The yellow highlighted comments from Electrical Engineer, which needs to be included in DFC. Next sheet is latest Output DFC file

Project:
MOBILE NETWORK AUSTRALIA
SITE No:- H8031
SNUG
120 LONGMANS ROAD

Drawing Title:
SITE LAYOUT AND SETOUT PLAN

Drawing Title: ELECTRICAL SPECIFICATIONS

DETAIL 1 / G2
SCALE 1:100

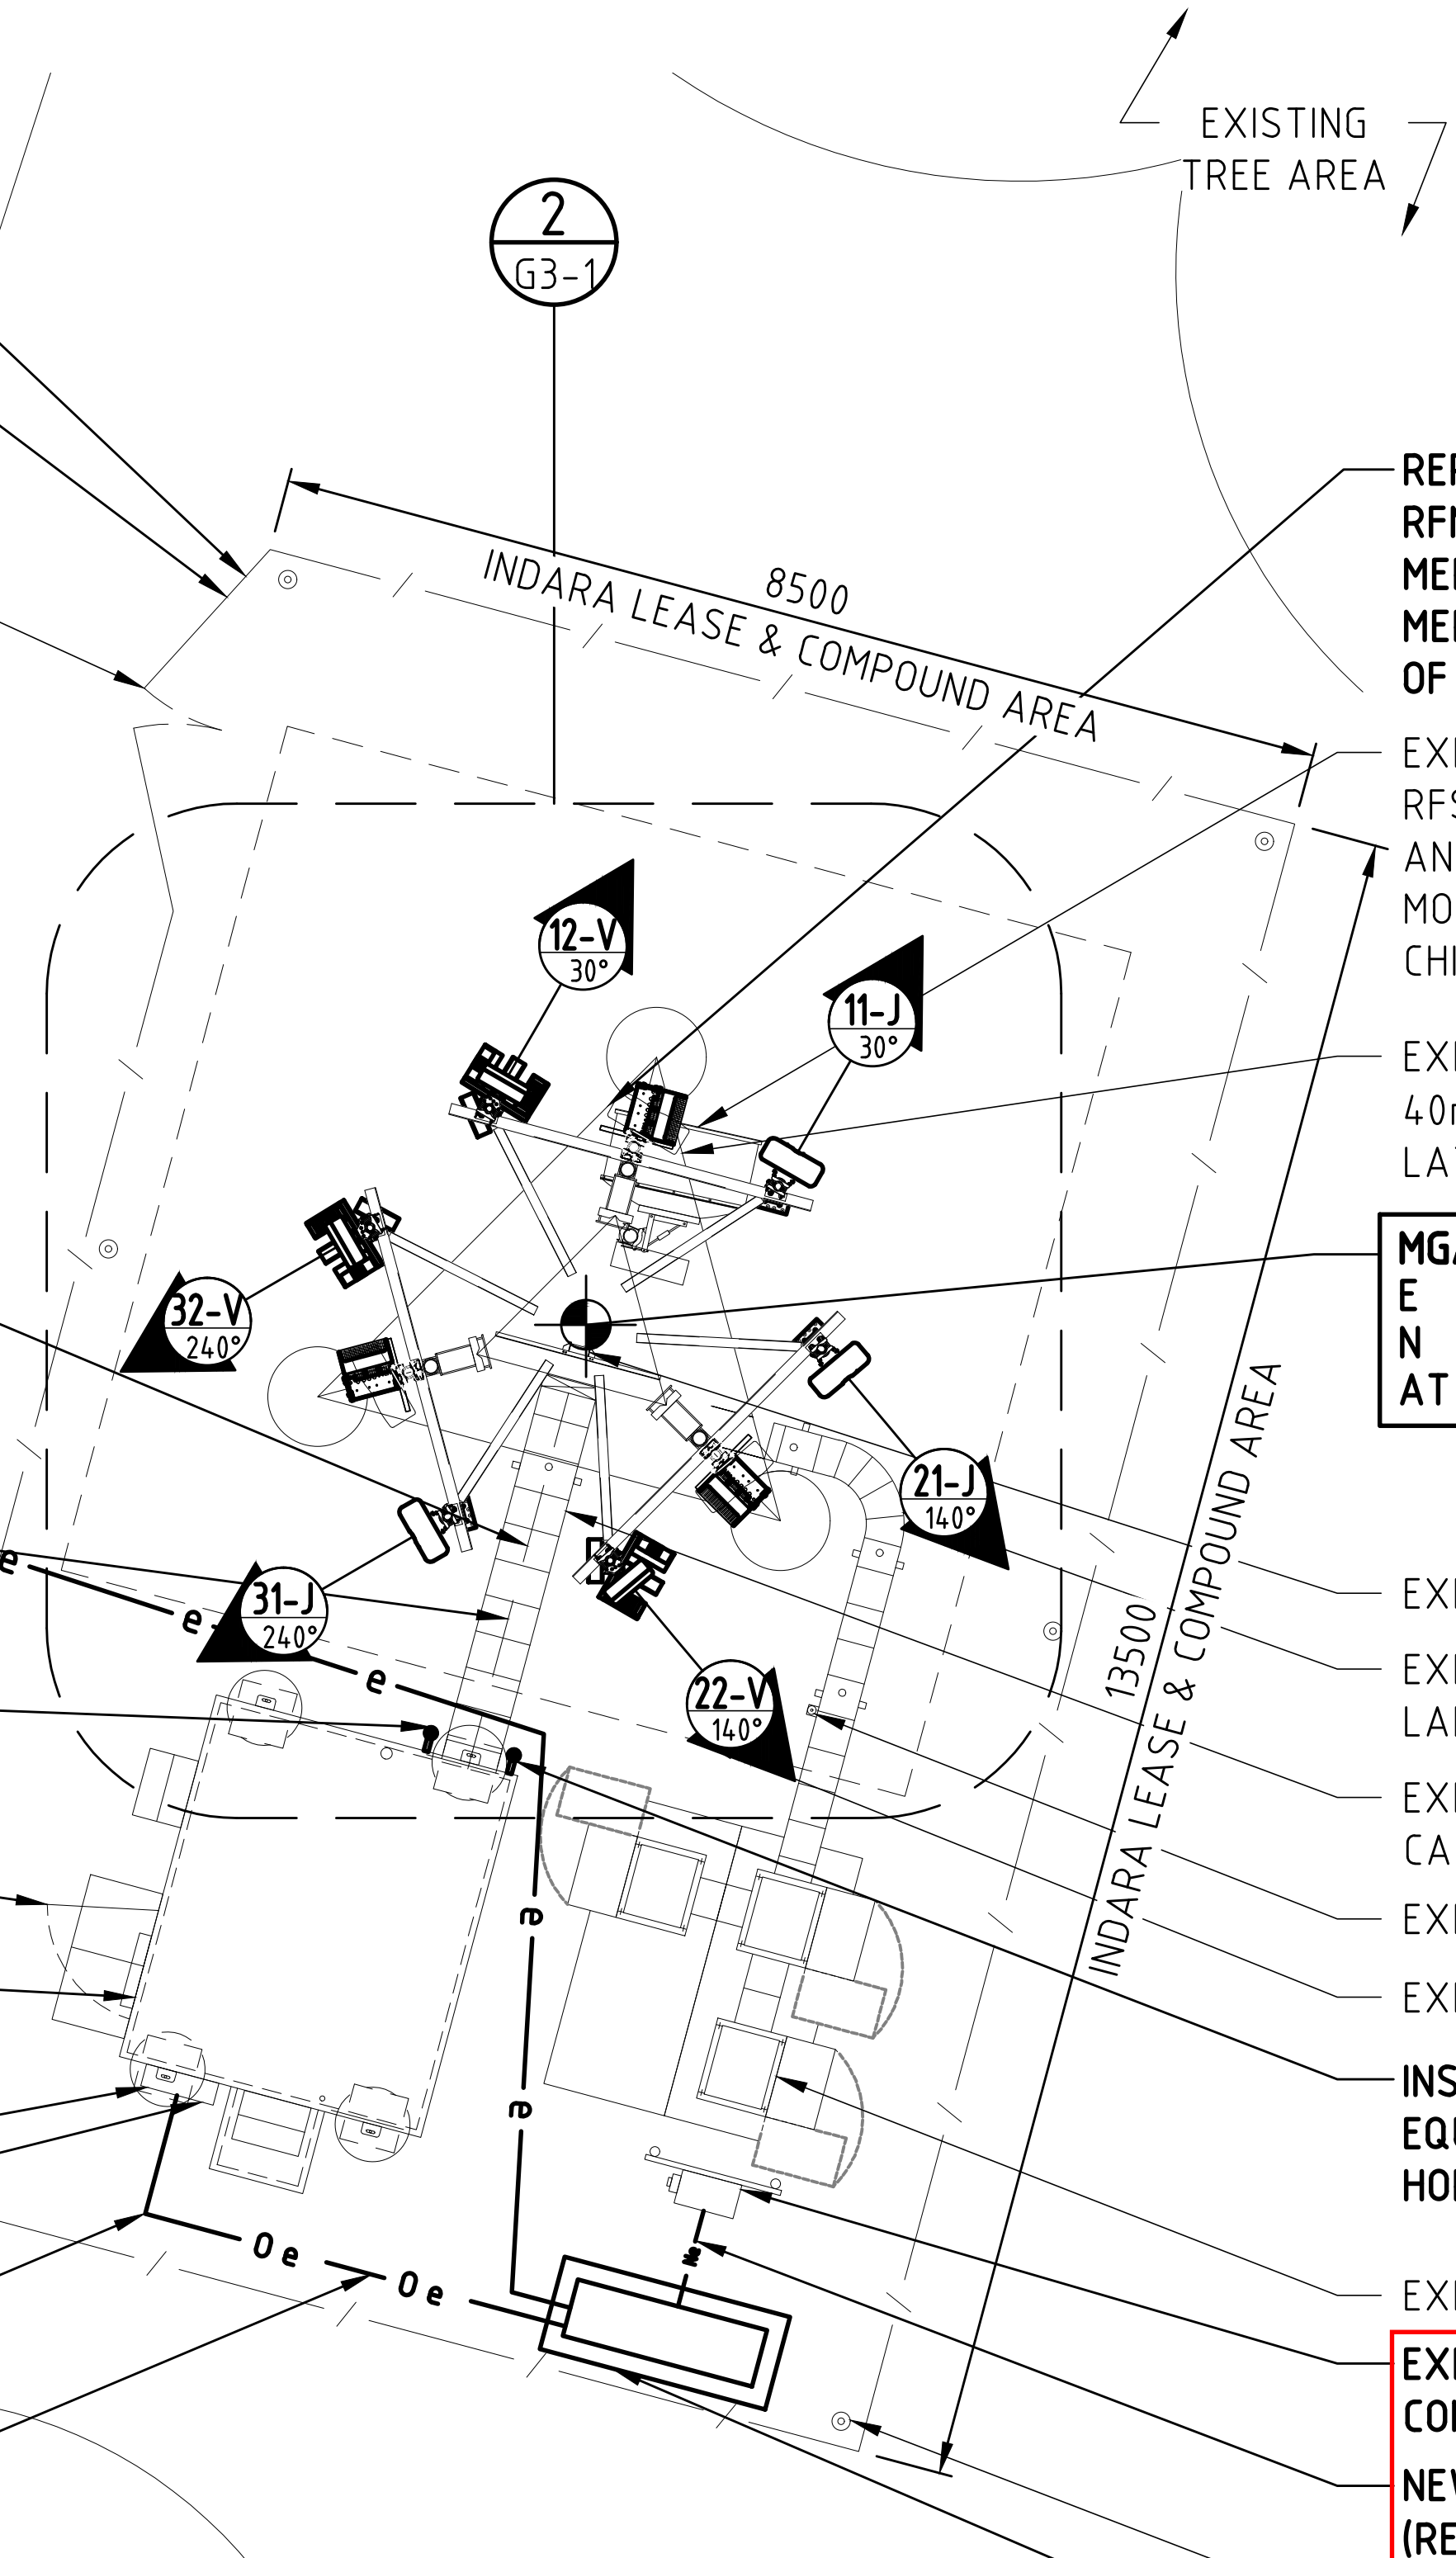
CONTRACTOR NOTE:
EXISTING HEADFRAME U-BOLTS WERE LOOSE/DAMAGED AT SEVERAL LOCATIONS. CONTRACTOR TO REPLACE WITH NEW U-BOLTS.

REPLACE EXISTING FADED KEEP OUT SIGNAGE ON EXISTING ACCESS GATE WITH NEW KEEP OUT SIGN

REPLACE EXISTING RFNSA NUMBER FADED MERCS-2 SIGN ON EXISTING ACCESS GATE WITH NEW MERCS-2 SIGN WITH CORRECT RFNSA NUMBER-7054003 HARD STAMPED

REUSE EXISTING VODAFONE H&S 6/12 HYBRID CABLES (3 OFF) (LENGTH IS 60m) (CHECK CONDUCTOR SIZE DURING CONSTRUCTION. IF THE TRUNK CABLE IS 6mm2, INSTALL Y-JUMPERS FOR AAU AVQL. IF THE EXISTING TRUNK CABLE IS 10mm2, NO Y-JUMPERS REQUIRED) RUN IN EXISTING OPTUS 450 WIDE ELEVATED CABLE LADDER

REMOVE EXISTING OPTUS AVA5-50 FEEDERS (6 OFF). REUSE EXISTING OPTUS H&S 9/18 HYBRID CABLES (2 OFF) (LENGTH IS 50m) RUN IN EXISTING OPTUS 450 WIDE ELEVATED CABLE LADDER

INSTALL NEW OPTUS ERICSSON GNSS GPS ANTENNA (1 OFF) ON TOP OF EQUIPMENT SHELTER WALL NEAR GLAND WINDOW. ENSURE MIN. 500mm HORIZONTAL SEPARATION FROM OTHER GPS ANTENNA

SINGLE LINE DIAGRAM

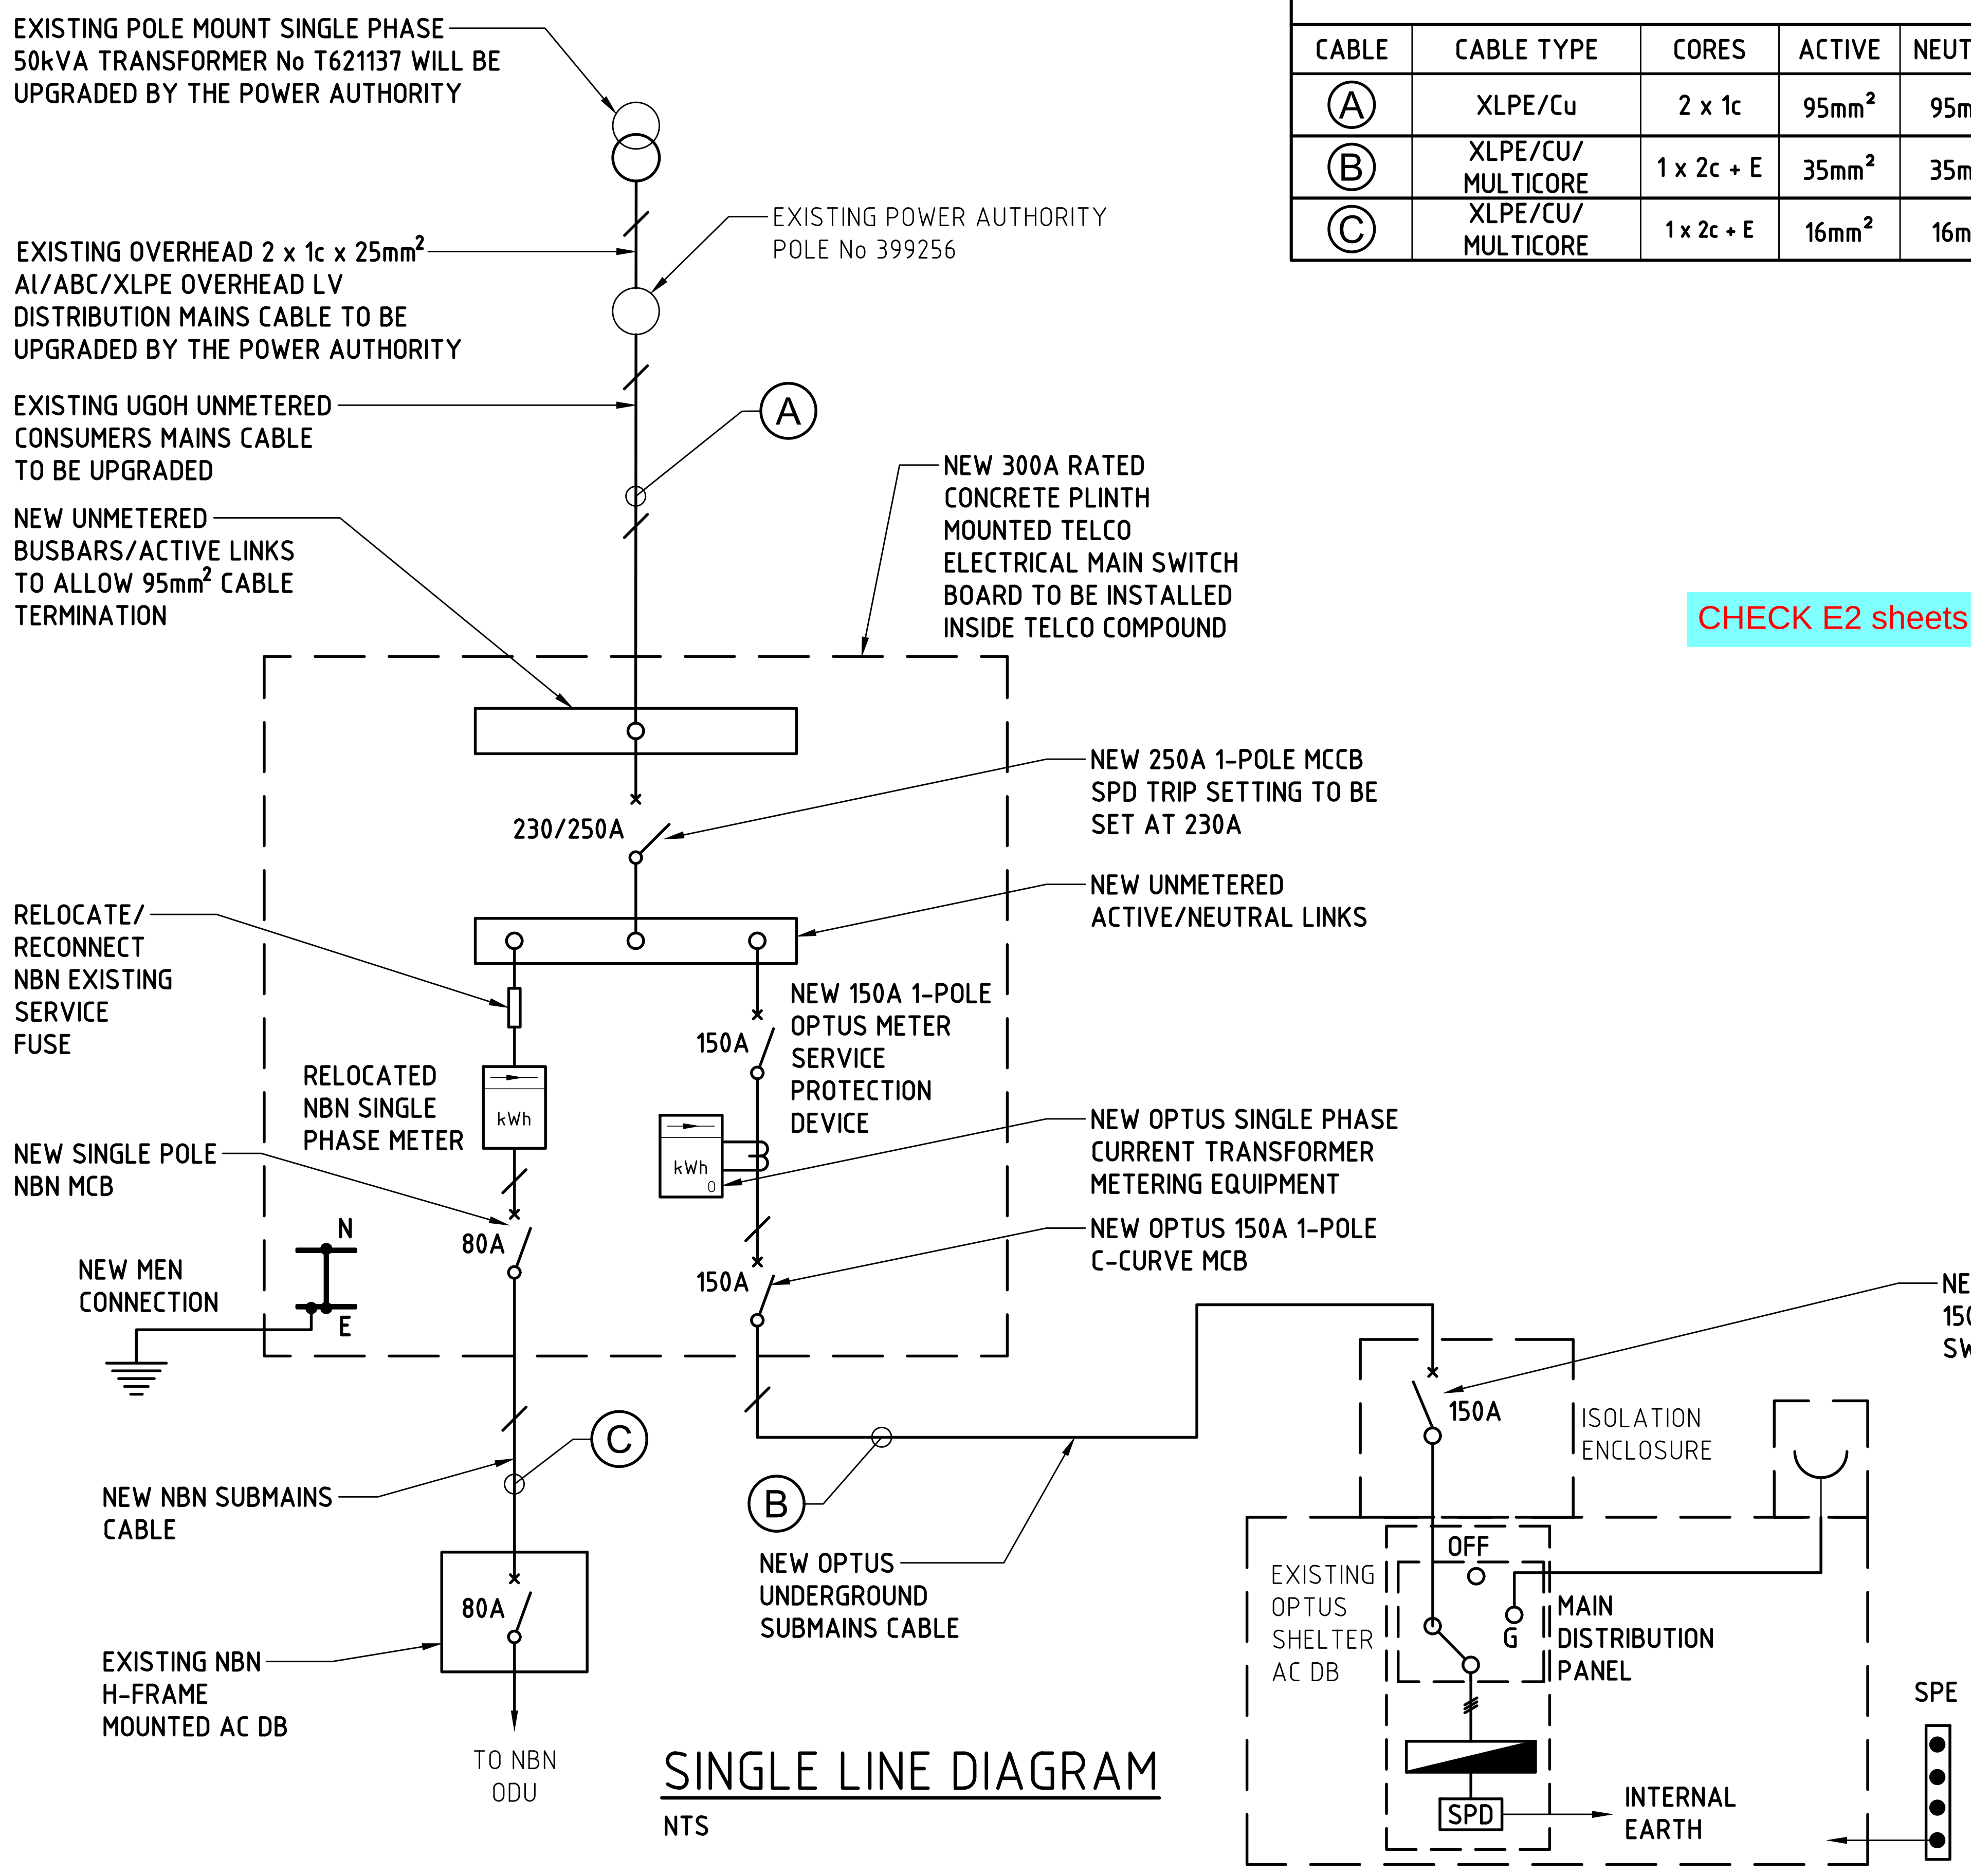
CHECK E2 sheets based on EE Markup
